3036127-LU

**1140 NW Market St
Seattle, WA
98107**

ADMINISTRATIVE DESIGN REVIEW

10.01.21

SE Aerial @ EDG

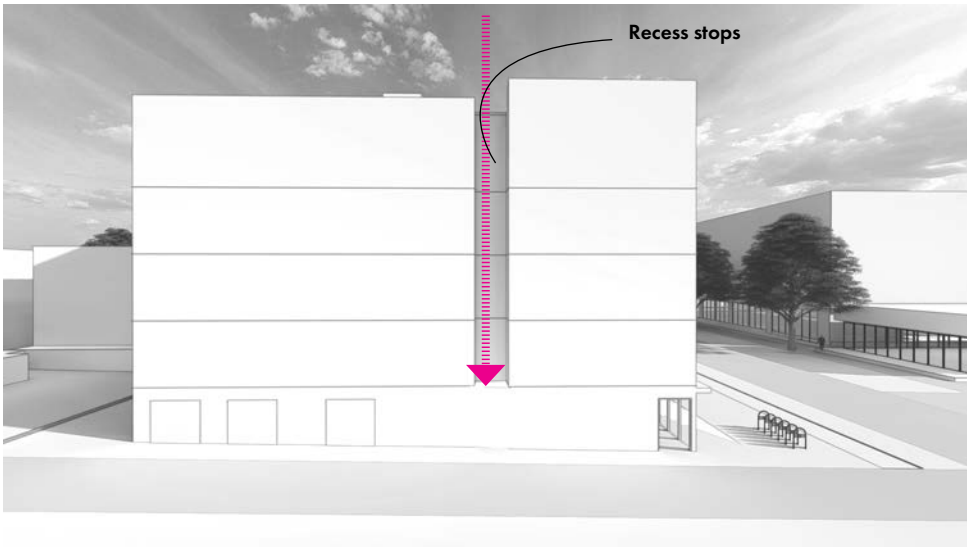
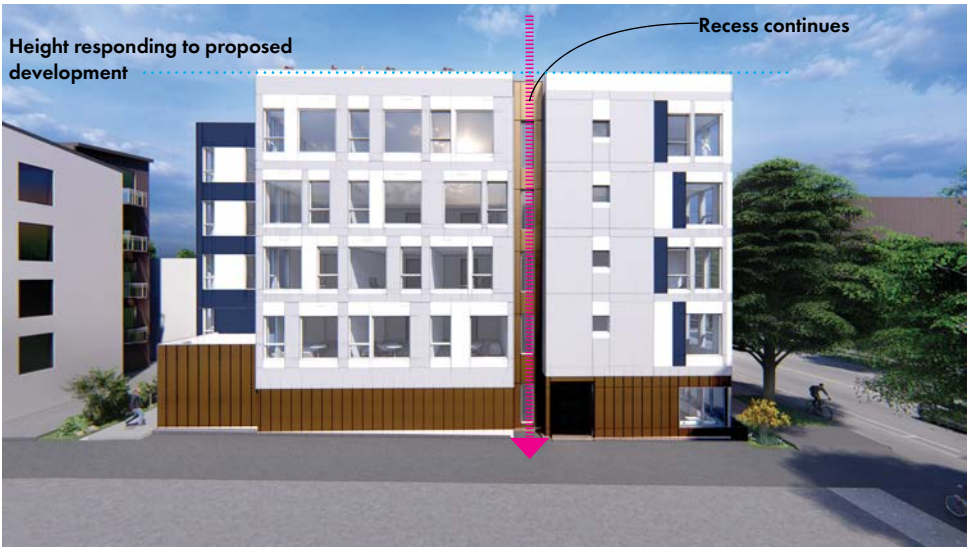
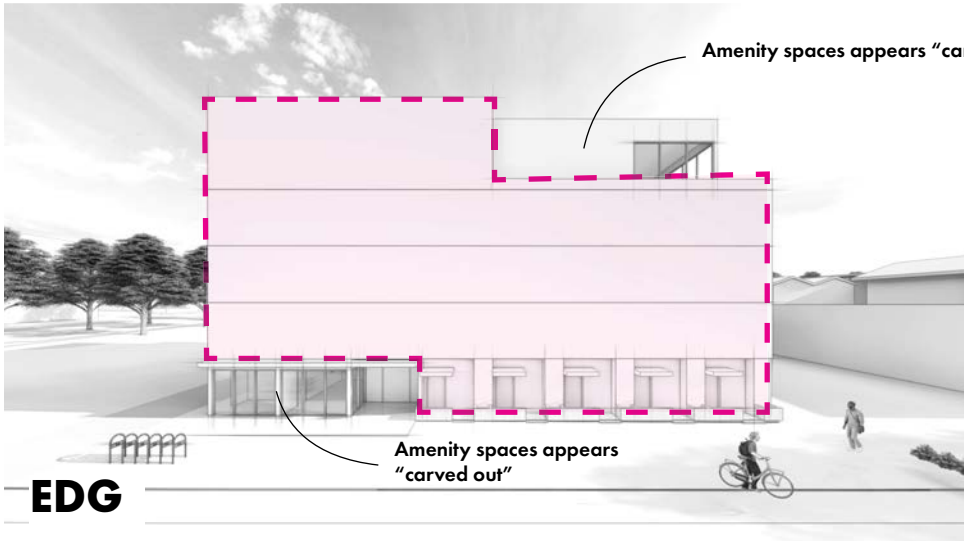
a. Staff appreciates the **extent to which the applicant has thoughtfully modulated each side of the building** with the use of what are discernable massing elements. The applicant should **explore ways in which to provide further hierarchy** between the modulated boxes. Provide architectural concept diagrams that help explain the overall design approach.

c. The perspectives and aerial views show a vertical recess from grade to the roof level on the west side of the building, splitting the overall massing into two discernable parts. The floor plans indicate that the slot stops at the second floor and **the ground floor alley façade** is flush along its length. Staff recommends **bringing the recess to grade** so that the ground floor façade is modulated. This will also allow for a clear visual transition from the amenity space at the corner and the building services further down the alley. CS2-B-2, DC2-A-2, DC2-4

a. Responding to the context is this proposal’s main goal. There is commercial to the West as well as a mixed used development; the project responds with a similar height. There is a small scale business to the East along with other residential; the project steps down and pulls back massing on the uppermost level. There is small scale residential to the NE; the roof form is kept low along and small scaled window articulation and cladding is proposed. There is a potential buildout of a medium scale residential shown to the NW; the project steps back an additional amount to provide more light, air, and privacy to the northern development in progress

c. The vertical recess now continues to grade to now further separates the two masses from each other along the alley and acts as a transition point for the amenity space in the plans.

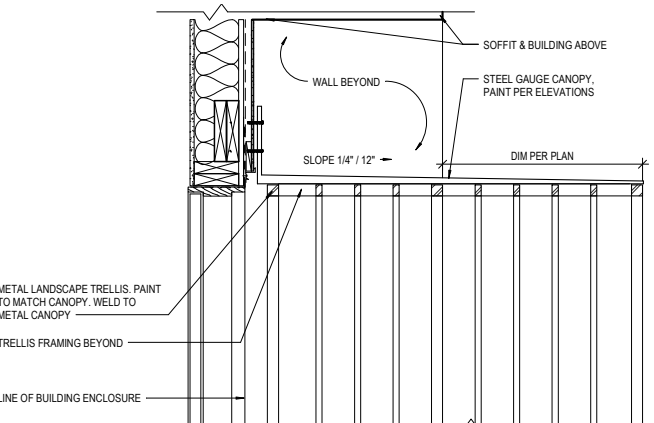
h. Although the street facing facades are paramount, the design of the north and east façades is critical because of its visibility from farther away. The façade concept and composition must therefore be **legible from various distances**. Provide diagrams and other graphics to help illustrate **how the façade** design takes this into consideration.

f. This project will be highly visible until the adjacent properties are developed; therefore, **design each façade to be attractive and well-proportioned**. Provide a **strong composition of elements**, including fenestrations, material placement, and secondary architectural features. DC2-B.1, DC2-B.2, DC2-C

h, f After studying several angles from adjacent blocks around the site, the following locations were found to have potential views. From the north, the corner through the alley will be visible; large windows turn both corners to provide visual interest. Also on the north through the existing townhomes, the NW corner is visible and a similar corner window approach is taken. From the Ballard Health Center to the East, the building is the most visible. Therefore providing high visual interest and transitioning the three façade treatments was carefully considered. The commercial treatment turns the corner and provides articulated paneling. The “carved” treatment creates a simple composition using high quality materials. The residential treatment provides visual interest with color and a small scaled design approach that mimics the other treatments. Farther Eastern and Western views will not be seen given the dense tree boulevard.

Residential Entries

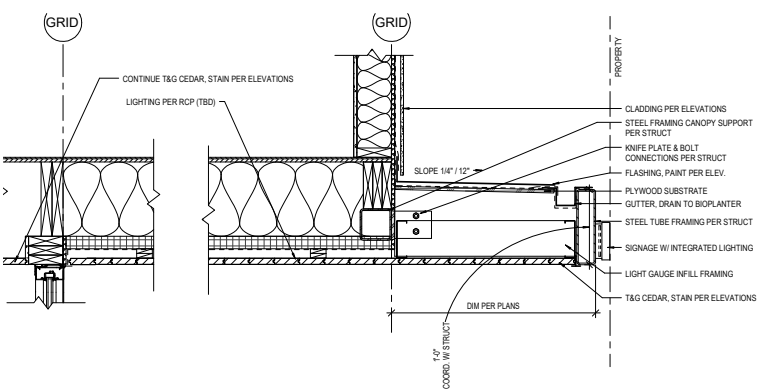
j. The **amenity space** façade design should be **commercial in nature** as it is a continuation of the retail to the west, and the facades of the **ground-related units** should serve as **transitional** between retail and the more residential scale to the east. PL1-A-2, PL3-C, DC2-B-1, PL3-4

i. Further develop the treatment of the **upper level setback** on the southeast corner where the amenity space and outdoor deck are located. **Incorporate secondary architectural elements** such as: larger fenestrations in the two SEDU units to the east of the top floor amenity space, intentionally placed canopies, a large overhang over the amenity deck, and other elements that are similar to those found on the ground level so that the overall composition of this overall massing is consistent. CS2-D-1, DC2-A-2

i. Distinction between the two natures of the entries starts with the subtle design cues the façade creates. It pulls back to expose simple materials at the main entry and amenity space but continues to frame the residential entries and their intimate scale. The “commercial” amenity has been designed with high quality materials, large operable windows, and landscaping that buffers the transition edge creating a connection to nature. A large wood canopy and wood wall emphasize the larger scale of the entry. Backlit signage at the planter and integrated signage at the canopy will further emphasize the point of arrival. The smaller residential entries take design cues from the entryway but those get scaled back; small canopies emphasize entry, offset paths call out to the private nature of the residential entry which is further articulated with raised planters. The façade frames each individual entryway to create an intimate entrance.

i. Both amenity spaces at the lower and upper levels are treated with the same high quality material approach. A canopy is located at the entryway on level 1 but is not carried into the amenity on the upper level due to it creating a top-heavy aesthetic that made the simple aesthetic busy. Also, transitions between canopy and the façade as it continues along the East became difficult. Because of the respect of privacy for the more residential program to the East, no roof deck is proposed on that upper level amenity.

Residential Entries

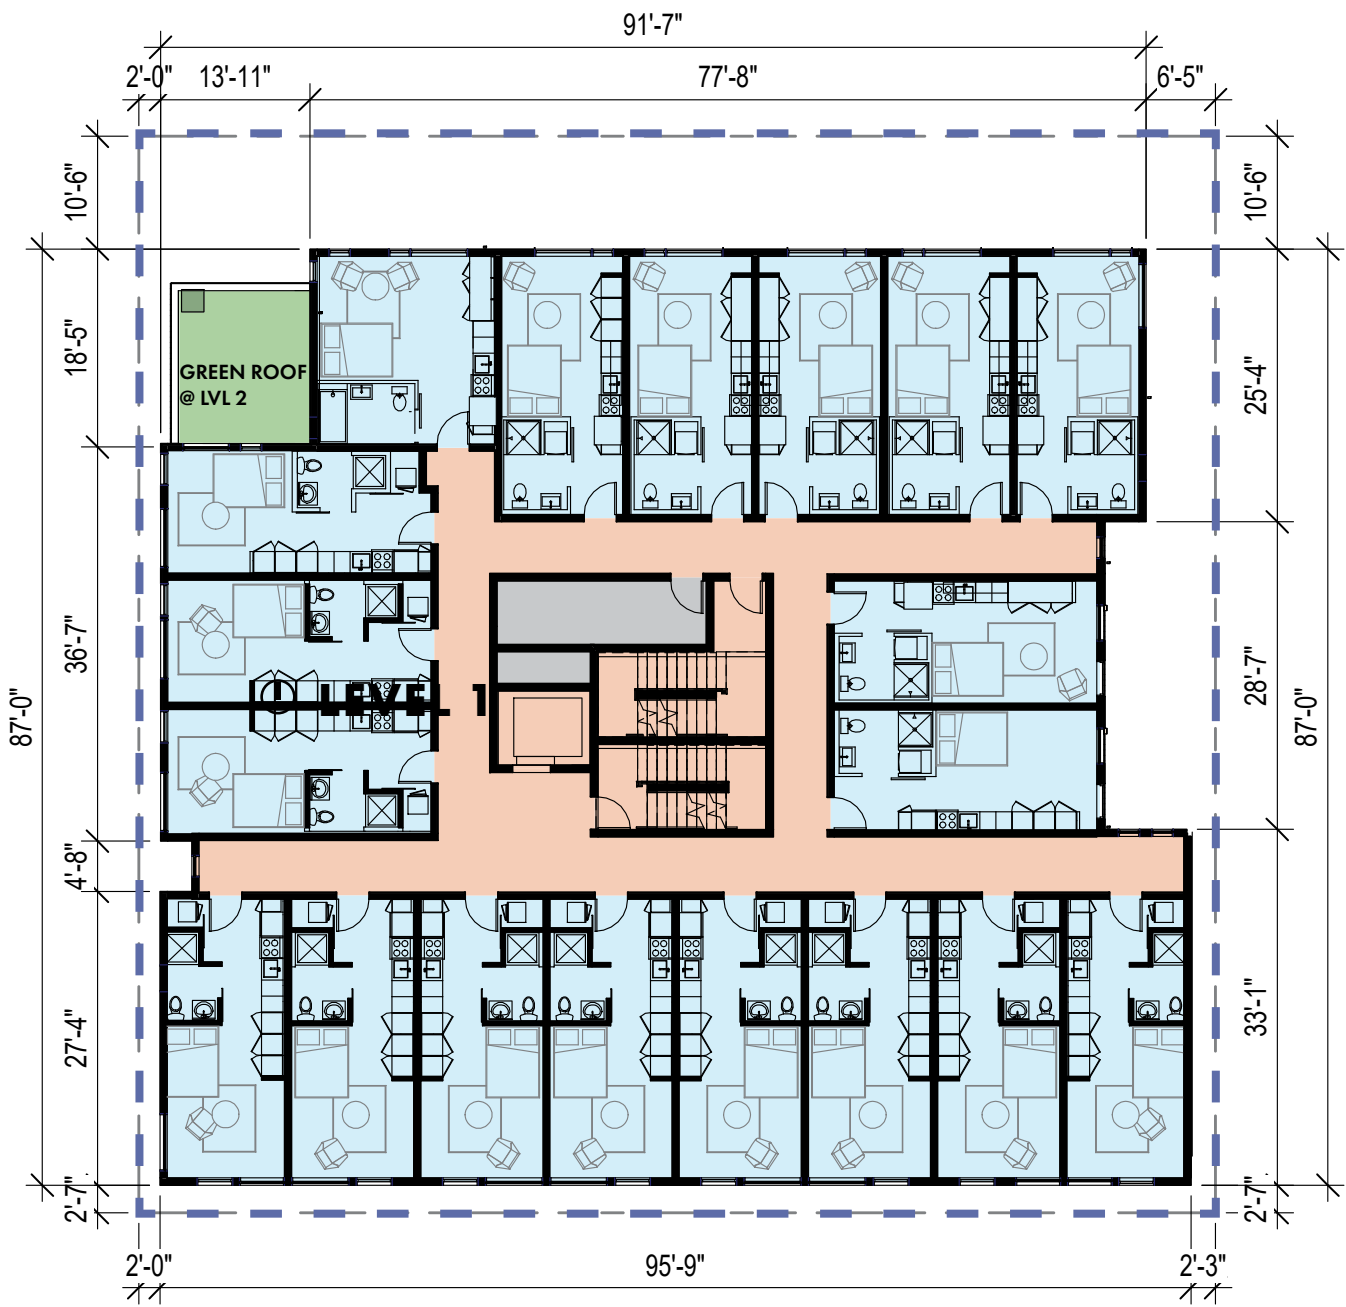
b. In conjunction with the item above, **study moving the landscape area** in front of the amenity space out **to the sidewalk edge** allowing for exterior amenity space that can help increase the activation of the pedestrian realm and the entry sequence. PL2-B, PL3-C, DC4-D-4

c. Although the design and articulation of the ground floor facing façade is interesting and engaging, Staff is concerned that the **main residential entry is not visible** or discernable amongst the various other entries along the street frontage. Continue **developing the entry hierarchy** using secondary architectural features or other means to increase wayfinding. PL1-B-3, PL2-B-3, PL2-D-1, PL3-A, PL3-1 thru 4, PL3-2

d. Move the main residential entry vestibule south or **provide a transparent corner** on the amenity space to the west to increase visibility and transparency. Study extending the entry canopy out beyond the property line to help increase the identification of the entry. PL1-B-3, PL2-B-3, PL2-D-1, PL3-A, PL3-1 thru 4, PL3-2

e. Further develop the landscape design within the **planted areas** in front of the **ground-related units** to provide a layered buffer with attention to height and seasonal interest. DC4-A

b. After consideration, it was felt that the planter was best kept situated as located for the following reasons. Privacy and security; unless the space in between the planter is enclosed, the outdoor space becomes a security risk. High Density foot traffic; by opening the entry pavers out and to the West to meet the sidewalk, there is more generous area for increased foot traffic. Connection to nature; large operable windows that open up to the planter are proposed, bringing outside elements indoors. The planter acts as a bioplanter; if the planter were to shift South, the project would lose valuable water retention.

c. The canopy over the main entrance has extended farther west to overlap with the amenity space, creating a more emphasized entry. The canopy then turns the corner, meeting the ground between the main entrance and unit entry to provide privacy between the two programs; this "L" feature further defines the main entry. The canopy material is carried in through into the vestibule that has integrated lighting that creates an intimate entry sequence. Warm materials are used for the planter to also define the entry as a focal point at the ground. The concrete paved entrance is proposed as smaller scaled pattern and visually overlaps the materiality of the sidewalk, creating a visual cue of where the main entrance is (dependent on SIP approval). The unit entry design has been lowered and has changed materiality; white metal canopies with landscaped trellises accentuate the entry and take cues from the overall parti diagram of the façade. Between the main entry becoming more visually prominent and the unit entrances becoming more subtle a sense of hierarchy is achieved.

d. To create a highly visible corner (and maintain a simple entry sequence), the amenity space was reoriented to follow the alley and large operable windows are proposed to open the space up to both the street and the corner into the alley ultimately activating the corner.

e. A gradient of low scale planting like orange sedge along the sidewalk up to medium scale planting like heavenly bamboo at the unit landing creates a visual buffer denoting privacy. This planting choice also creates color and seasonal interest. Snowdrift vines are planted adjacent to the entries and will grow up the trellis framing the canopies which provides height and layered interest in the landscape.

DEPARTURE REQUEST
PREFERRED

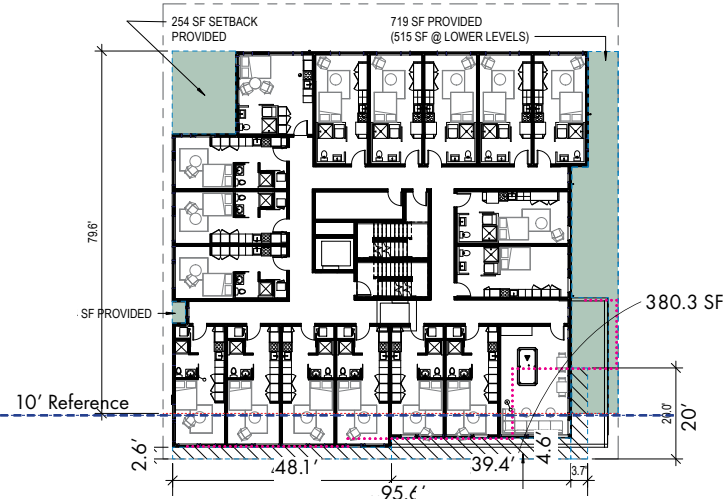
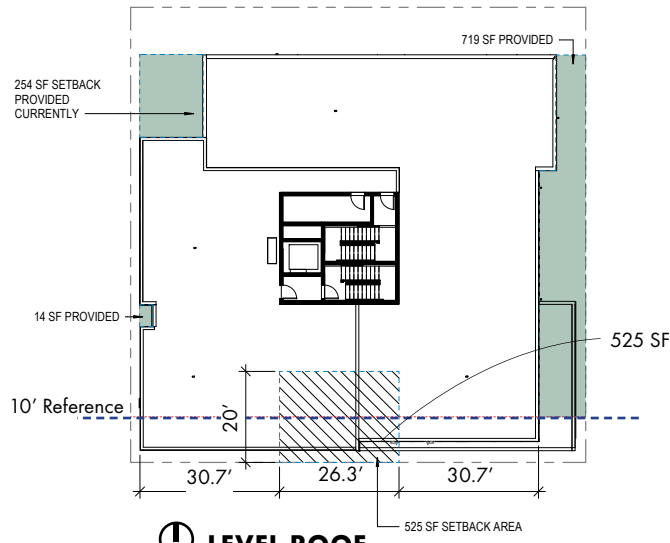
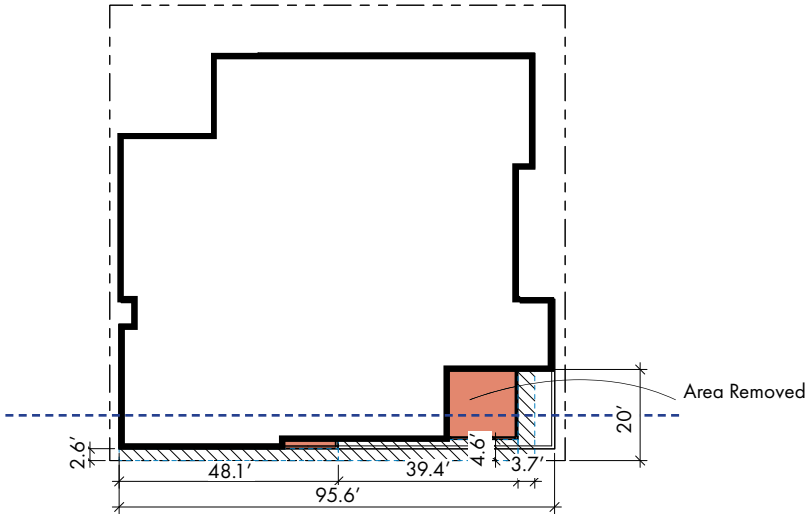
Request
To allow the average upper level street setback above 45' to be 7.3' where 10' is required resulting in a departure of 25.8% and 2.6'

Rationale
The proposed design provides additional setbacks along the north and east facades that respects the neighbors and responds to the site context. The proposed design creates three interesting facades (north, east and south) with cohesive fenestration, modulation and increased light and air for the project as whole. All three facades complement each other to create an overall more cohesive design. If the upper level setbacks are averaged without the 20' max depth limitation on the roof level, the preferred design exceeds the upper level average setback requirement. Penthouse: 26.3 x 35.16' (20' max dimension per code) = 924.88 sf + 380.3 (5th floor) = 1,305.18 (11.11' avg. setback) > 1,175 sf (10' req. setback average. area). The intent of the upper level setback is also met, as the massing provides relief on the upper levels moving east, while maintaining strong and more cohesive overall design. The upper level penthouse is centered in the building lessening impacts on neighbors that can occur when circulation is located near the exterior of a building. City Wide DC2: B.1, C.3 / CS2: C.2, D.1, D.3, D.4 / CS3 - A.1 Ballard Specific DC2: 1.a, 2.a / PL1: C.1, C.3
